**TOWN OF BAY HARBOR ISLANDS
DEVELOPMENT & REVIEW COMMITTEE MEETING
THURSDAY, OCTOBER 13, 2022**

**TOWN OF BAY HARBOR ISLANDS
COMMUNITY DEVELOPMENT
MEMORANDUM**

Subject: Site Development Plan Application – DRC Review #2
Proposed New Multiple-Family Development (44 DU)
Existing Bay Harbor Tower Site (30 DU)
10141-10143 East Bay Harbor Drive
Bay Harbor Islands Acct. No. SPR22-000024
MMPA Acct. No. 01-0702-1142

ZONING INFORMATION

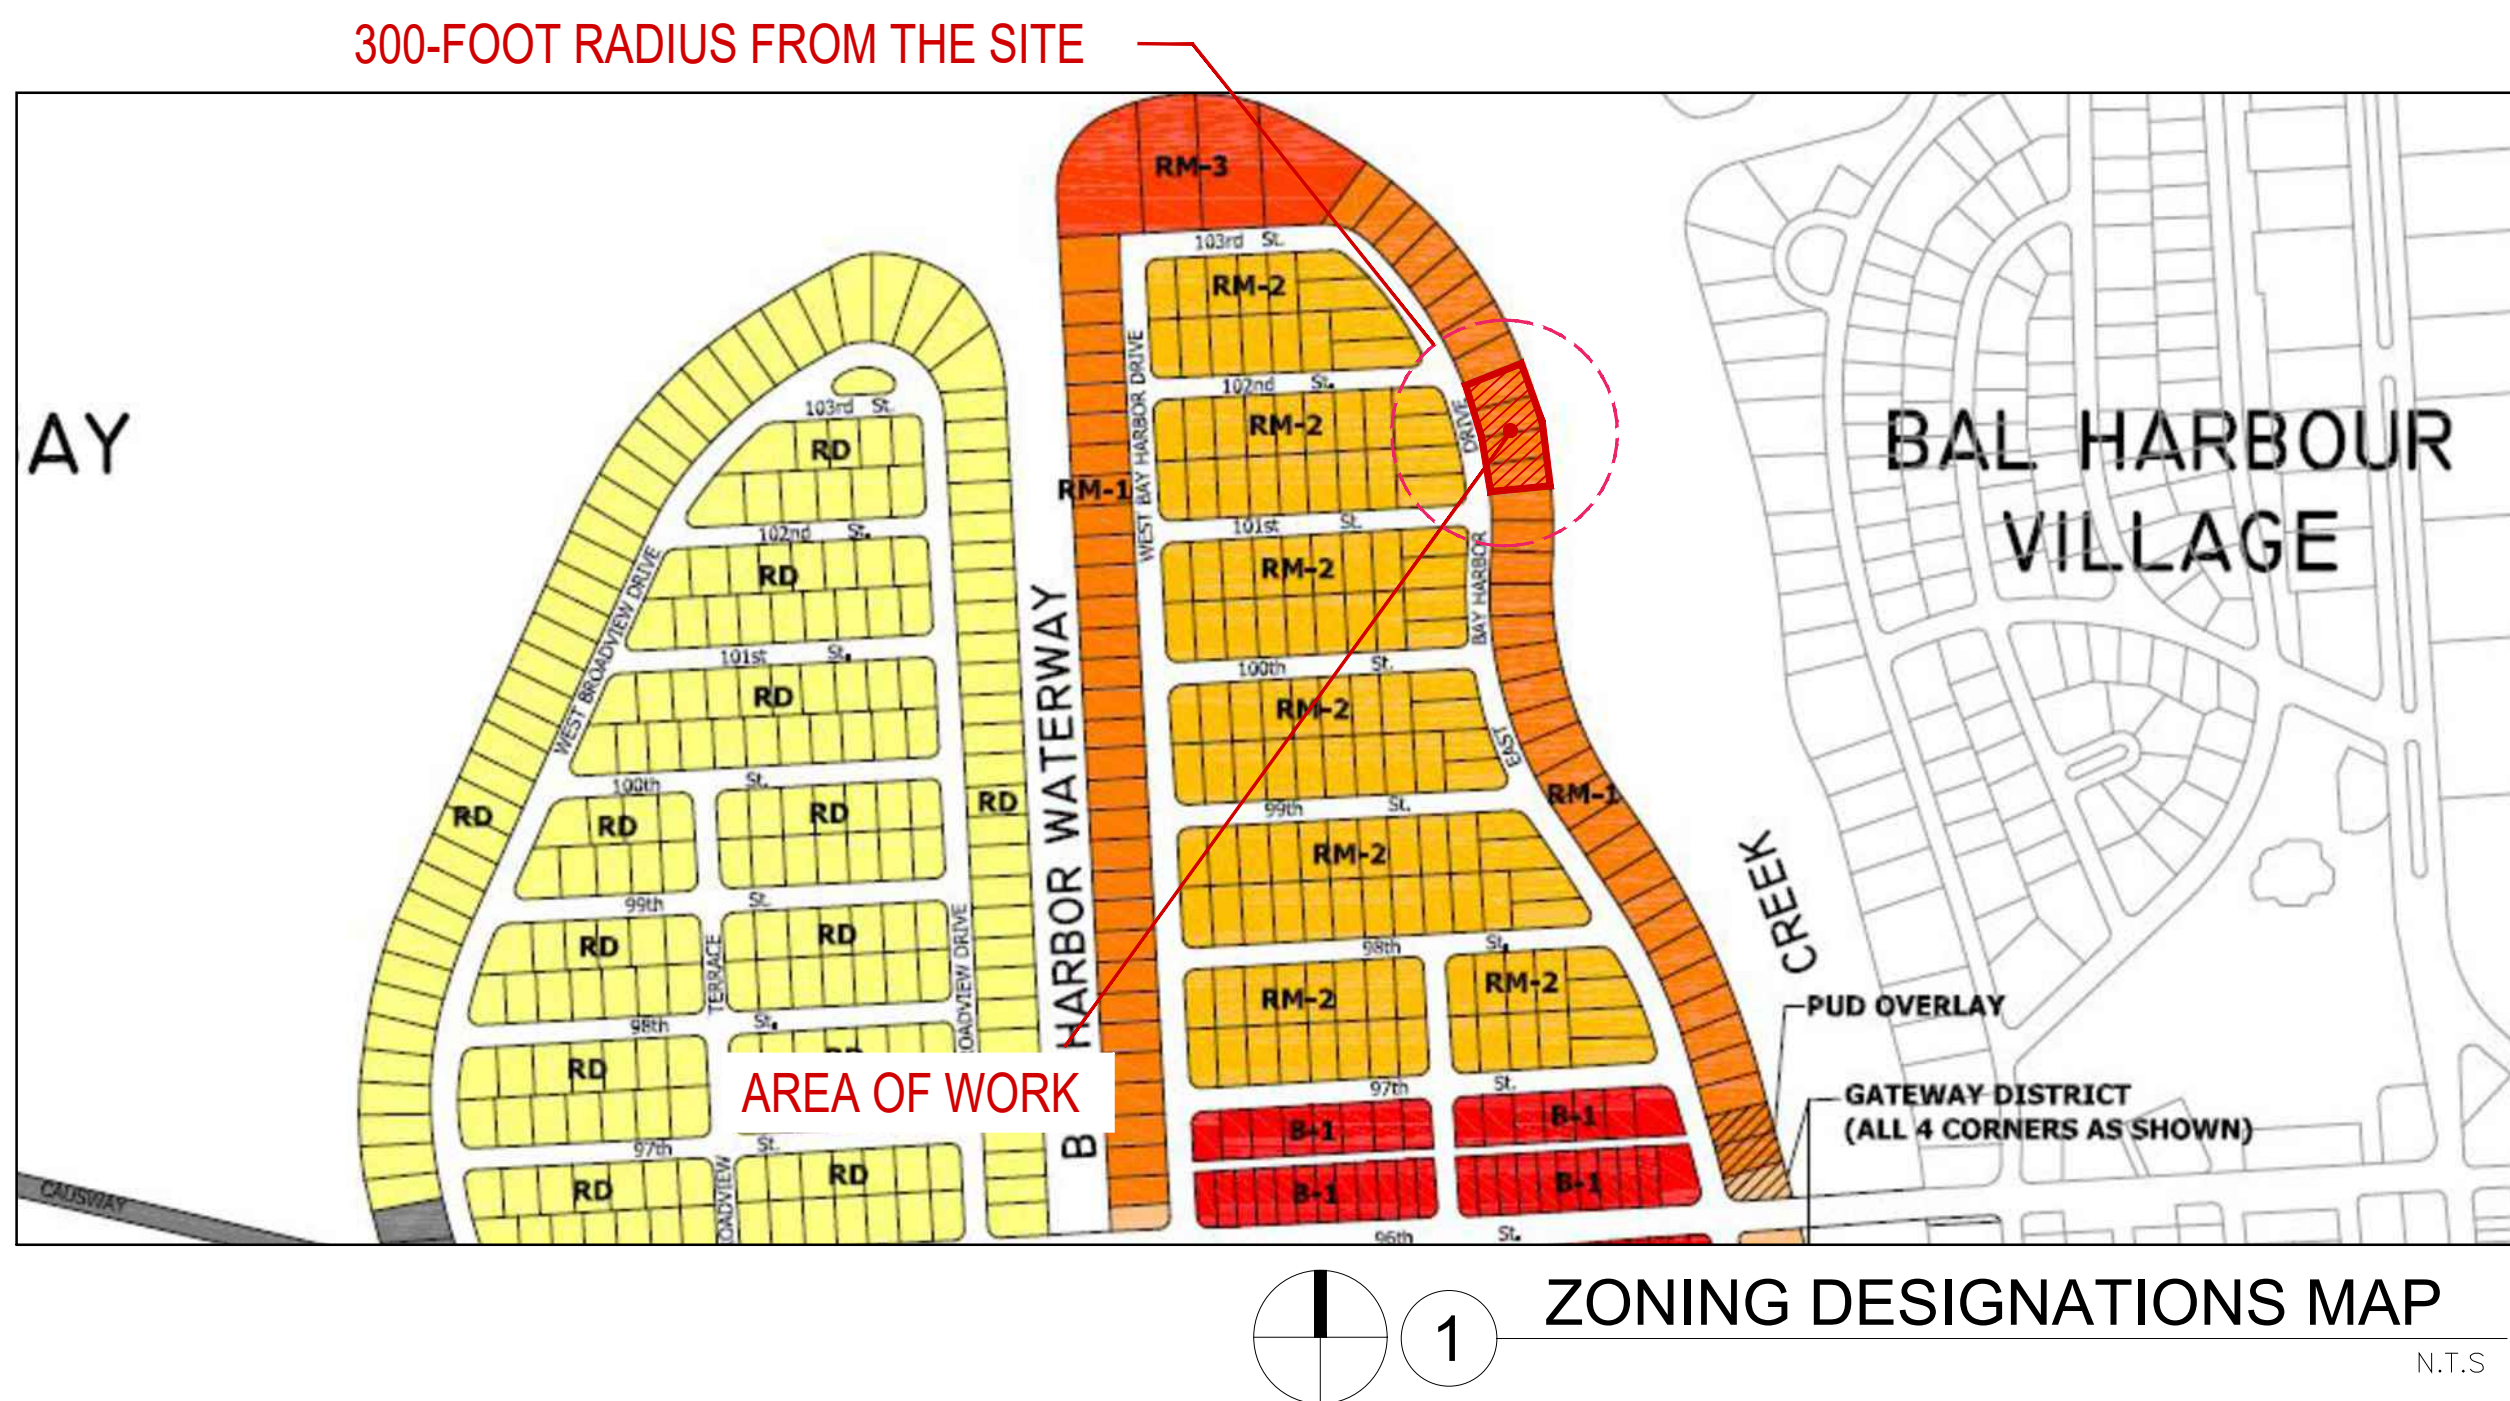
1. On Sheet A1.00 of the new plans in the Zoning Information / Site Data Table there is a breakdown of the proposed parking spaces by type. Based on our review this calculation data is correct. However, on Sheet A2.00 a similar parking breakdown calculation table does not match and is incorrect. Please revise the plans (Sheet A2.00) to present accurate information and be internally consistent.

PROJECT: 10143 East Bay Harbor Dr		 KOBİ KARP ARCHITECTURE INTERIOR DESIGN PLANNING	
MASTER PERMIT #:		REVISION DRC CITY COMMENTS 09/28/2022	
COMMENTS RESPONSES:		ELECTRICAL REVIEW - ERIC MERCED - 09/14/2021	
CONSULTANT			RESPONSES
ARCHITECTURE	1	On Sheet A1.00 in the Zoning Information Table the following issues are noted: >The table does not include a reference as to the required breezeway requirement or how this site complies. Only the building length calculations are provided. Please revise the plans to include the calculations. >As related to the proposed DU sizes there is no information provided as to the Code minimum DU size requirements nor proposed DU sizes demonstrating compliance. Please revise the plans to include this required information. >As related to the parking requirements, the plans state that 88 "standard" parking spaces are provided. A "standard" parking space is 8'-6" x 18' single vehicle side-byside per Sec. 23-30(a) with striping / car stops. As mentioned above the site plan includes a total of 88 parking spaces. Of the total 88 parking spaces provided, mechanical lifts are proposed for 16 spaces, 20 spaces are proposed for tandem parking spaces, drive-aisle valet parallel spaces are proposed for 15 spaces, and 37 traditional parking spaces are proposed. Revise the table to include this breakdown, even though it is listed on other sheets. Basic site information should be in one cohesive location for ease of review.	Table including breezeway requirements, information on DU and parking requirements has been added to sheet A1.00

Date	09-29-2022	Sheet No.	A2.00
Scale			
Project	0000

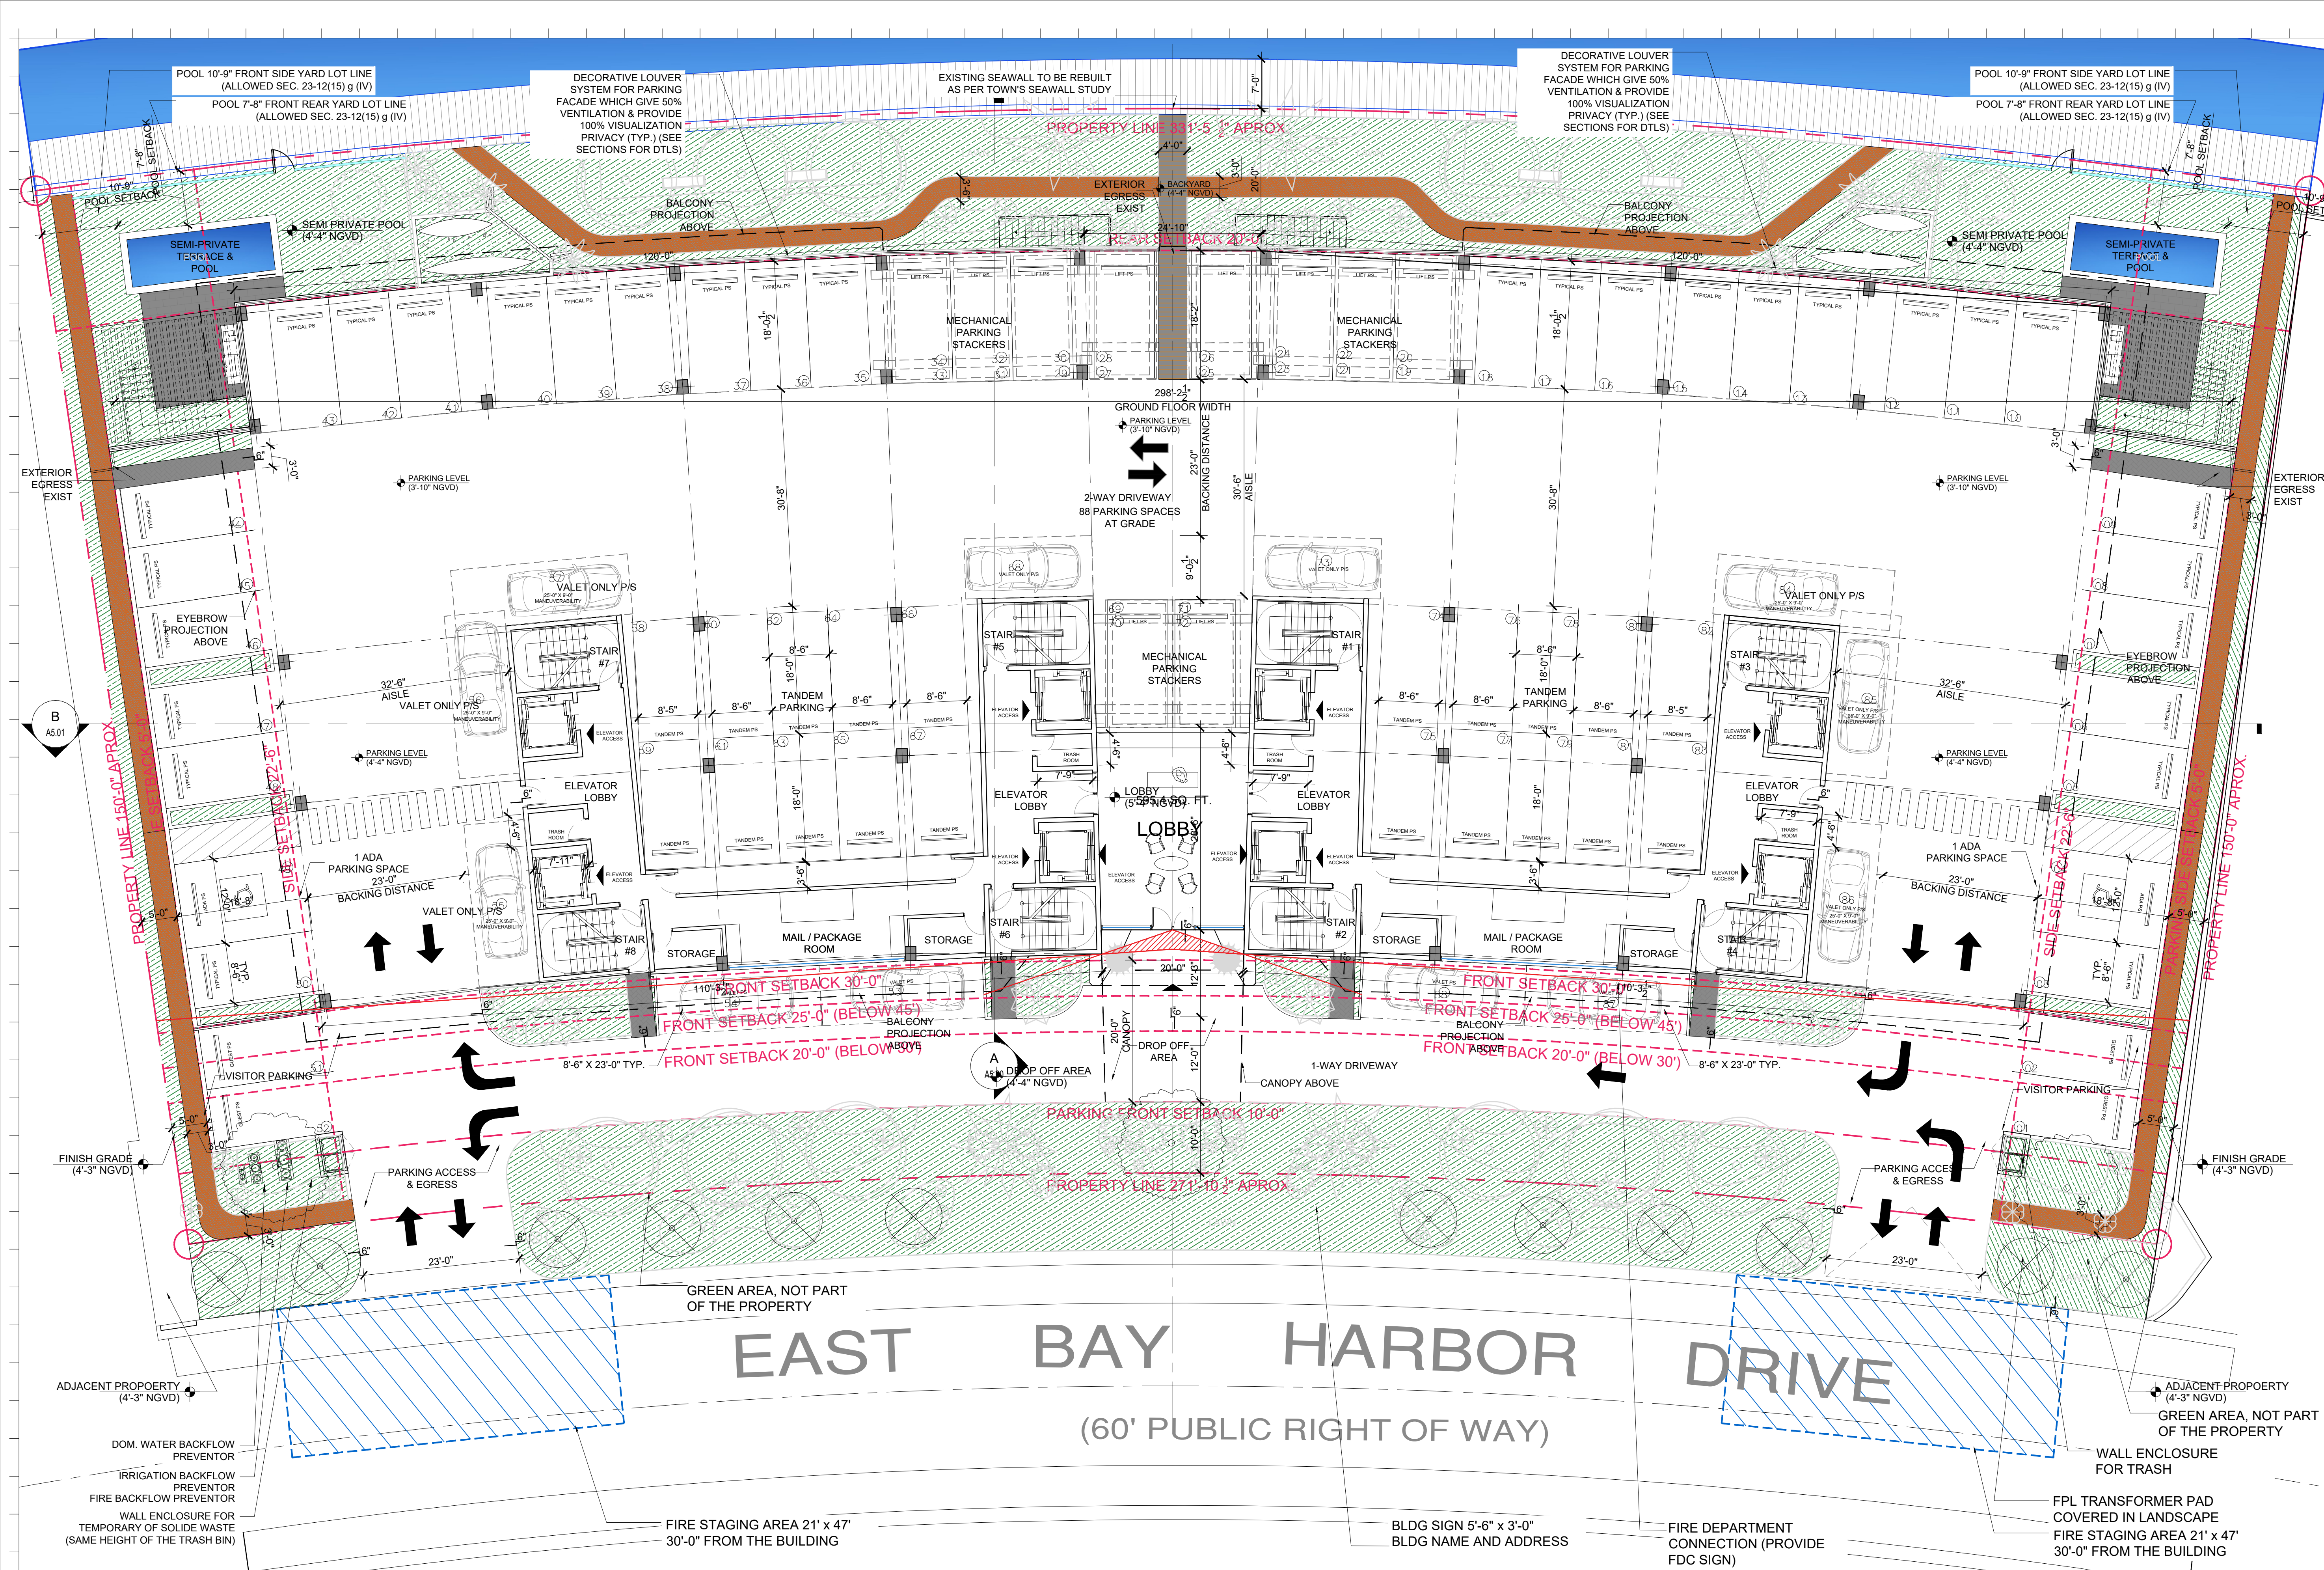
3. On Sheet A2.00 and Sheet A3.00 there are errors with the rear yard swimming pool locations and referenced Code sections. For waterfront sites Sec. 23-12(15)(g)(i) applies – not subsection (iv) as that applies to non-waterfront lots. Pools / pool decks can be located not less than 5' to the rear PL / seawall – the plans show 7'-8" for some reason. You can leave them as shown or relocate them. However, Sec. 23-12(15)(g)(i) prohibits pools from being placed in the minimum side setbacks – the plans show the 2 semi-private pools partially within the min. 22.5' side setbacks. Please revise the plans accordingly.

4. On Sheet A2.00 / Sheet A3.00 / others there are setback violations shown for the proposed 3' wide walkways along the side lot lines. Per Sec. 23-12(15)(b) no such walkway may be placed closer than 3' to a side lot line, as this area is needed for drainage and buffering. The plans provide no setback dimension but a 5' setback from the parking spaces is shown with a 3' width shown for the walkway leaving only 2'. Also, a physical barrier to screen the parking areas from the adjoining sites are required per Sec. 24-16. Please revise the plans accordingly.

5. On Sheet A2.00 / Sheet A3.00 / others there appears to be some type of private terraces near the semi-private swimming pools at grade level. Not enough detail is provided to determine Code compliance as to setbacks / materials / roof coverings / height / etc. The elevations seem to show a roofed structure – so setbacks are required. Please revise the plans accordingly. See Sec. 23-12(15)(e)(iii) for Code allowances.

3	On Sheets A1.01, A2.00 and others the plans show grade level pools / pool decks and sitting area in the rear yard adjoining the waterway. Sec. 23-12(15)(e) requires a min. 5' landscape strip between the rear property line and any walkway / patio / pool / pool deck. This is required for compliance with the EPA NPDES drainage permit to pollutants can be retained on-site and not discharged into Biscayne Bay — a federally protected water body. Please revise the plans accordingly. Occasional perpendicular walkways from the upland areas to the seawall / docks are acceptable (5° width max.).	Plans have been reviewed accordingly. Please see sheets A1.01, A2.00
	4	On the Site Plan drawings (architectural / civil / landscaping) curvilinear walkways are shown in the side yards which is allowed; however, per Sec. 23-12(15) no portion of a walkway can be placed closer than 3' to a side lot line to allow for proper on-site drainage and landscaping. Revise the collective plan set to comply with minimum Code requirements.	Plans have been reviewed accordingly. Please see sheets A2.00 and A3.00

5	On the Site Plan drawings (architectural / civil / landscaping) walkways are shown in the front and rear yards which is allowed; however, per Sec. 23-12(15)(b) no portion of a walkway can be wider than 5" in those yard areas. The plans fail to include dimensions for many site features, including the walkway setbacks and widths. MMPA scaled the front / rear yard walkways at 6'+ in width. Revise the collective plan set to comply with minimum Code requirements.	Dimensions have been provided see sheets A2.00 & A3.00
